Intel® 64 and IA-32 Architectures Software Developer's Manual

Documentation Changes

March 2007

Document Number: 252046-019

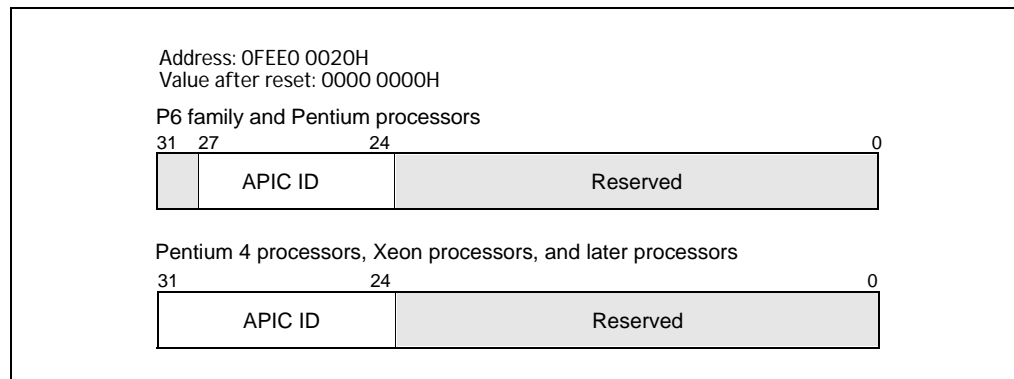
6. More information about R8-15 & XMM8-15 transitions

In Section 3.4.1.1 of the *Intel® 64 and IA-32 Architectures Software Developer's Manual, Volume 1*, information covering mode transition behavior for R8-15 and XMM8-15 has been added. This information has been reproduced in context below noted by change bars.

Registers only available in 64-bit mode (R8-R15 and XMM8-XMM15) are preserved across transitions from 64-bit mode into compatibility mode then back into 64-bit mode. However, values of R8-R15 and XMM8-XMM15 are undefined after transitions from 64-bit mode through compatibility mode to legacy or real mode and then back through compatibility mode to 64-bit mode.

Figure 8-10. Divide Configuration Register

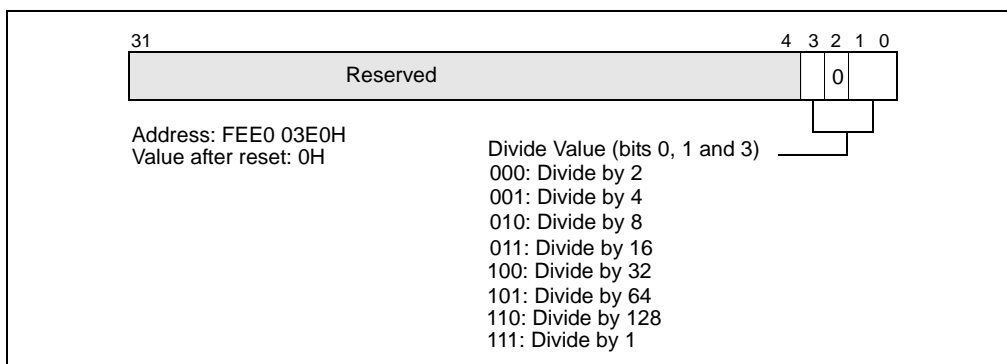
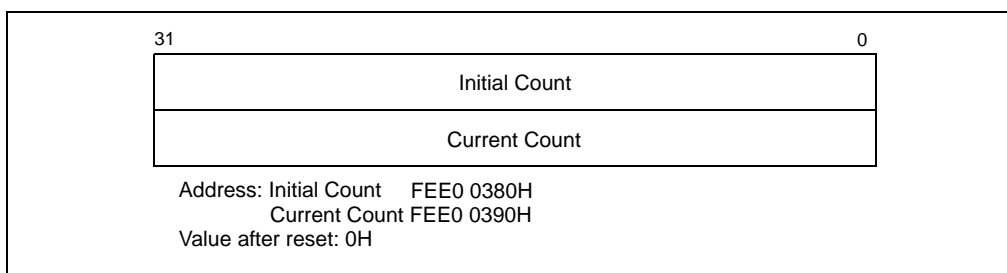
8. Note added to section on APIC timer

In Section 8.5.4 of the *Intel® 64 and IA-32 Architectures Software Developer's Manual, Volume 3A*, a note has been added (discusses deep C-states and GV3 transitions). Part of the section is reproduced below with the change in context noted by change bar.

NOTE

The APIC timer stops incrementing when the processor is in deep C-states (C3 or higher). It also does not increment during GV3 transitions.

Figure 14-5. IA32_MCI_STATUS Register

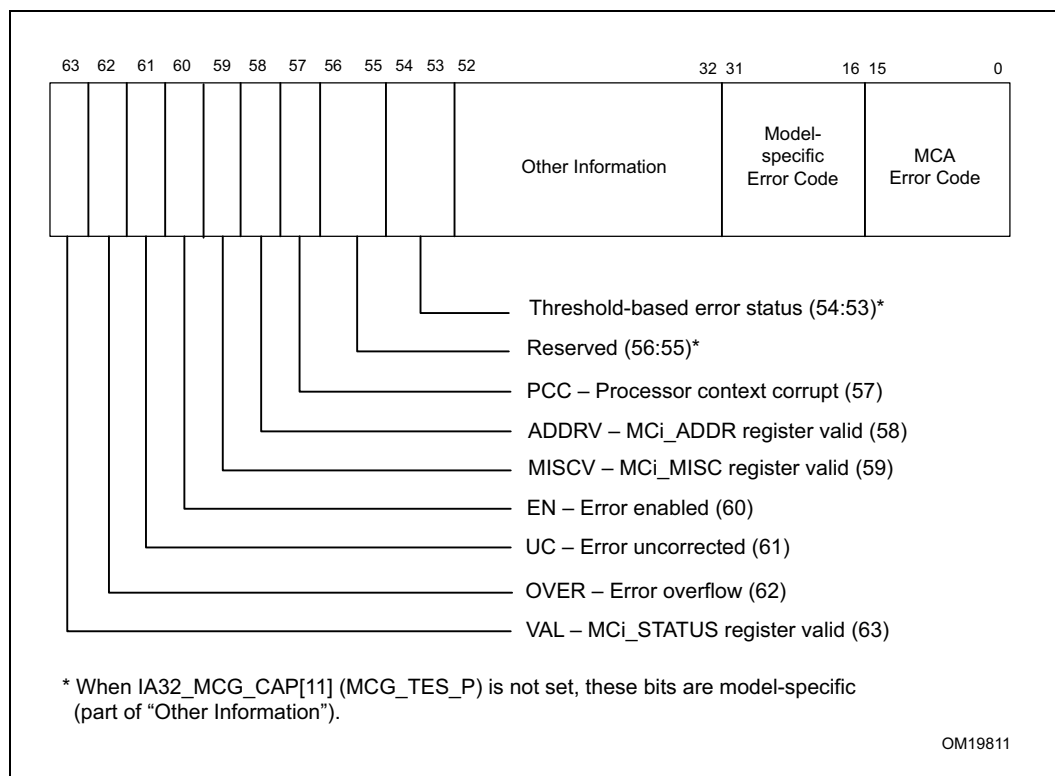
16. IA32_MCI_STATUS figure corrected

In Figure 14.5 of the *Intel® 64 and IA-32 Architectures Software Developer's Manual, Volume 3A*, a field definition has been corrected. The figure is reproduced below. See the model-specific error code field.
